### Addendum #3

3 May 2021

**Westbrook Armory Renovation, 120 Stroudwater Avenue, Westbrook, Maine, 04092, Project Number 23SR19-427-D, BGS Project Number 3034, Bid Number 21-022.**

SHEET ID:  
AD-103  
SHEET: 44 OF 145

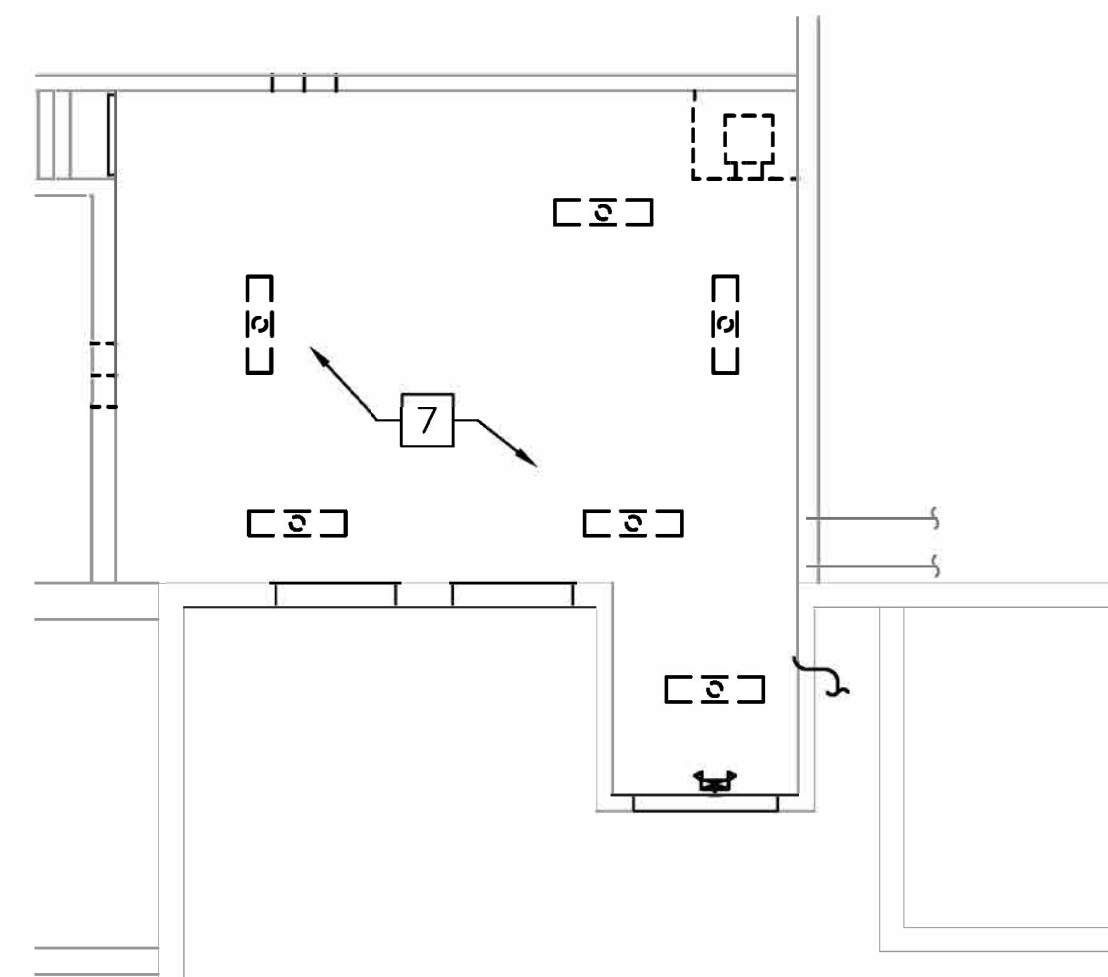
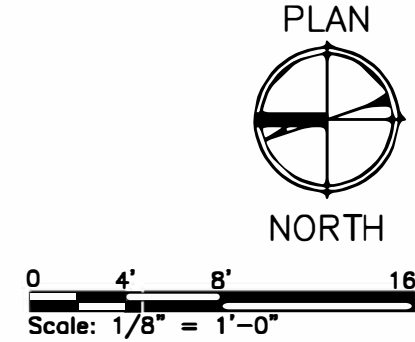
11. **Question:** Plan page AD-103 & ED-101, Alternate Bid Item (ABI) states: "Completely remove High Bay Lighting back to energizing source." Plan Page E-103 states: "Provide new LED high bay light fixture as indicated on the light fixture schedule". Please clarify as this is in conflict with the only alternate in the specification and Bid form?

1. Remove Drawings Sheet AD-103 Reflected Ceiling Demolition Plans, replace with revised Drawings Sheet AD-103 Reflected Ceiling Demolition Plans. Corrected ABI #2 – Replace Highbay Lighting fixtures.
2. Remove Drawings Sheet E-103 Electrical Lighting Plan, replace with revised Drawings Sheet E-103 Electrical Lighting Plan. Corrected ABI #2 – Replace Highbay Lighting fixtures.

**Answer:** Alternate #1 on Drawings AD-103 and ED-101 has been changed to Alternate #2 and corrected on bid form 00 41 13 Contractor's Bid Form, Page 3 of 4. Remove existing fixtures and install new LED fixtures.

**ABI #2** COMPLETELY REMOVE HIGHBAY LIGHT FIXTURES BACK TO ENERGIZING SOURCE.
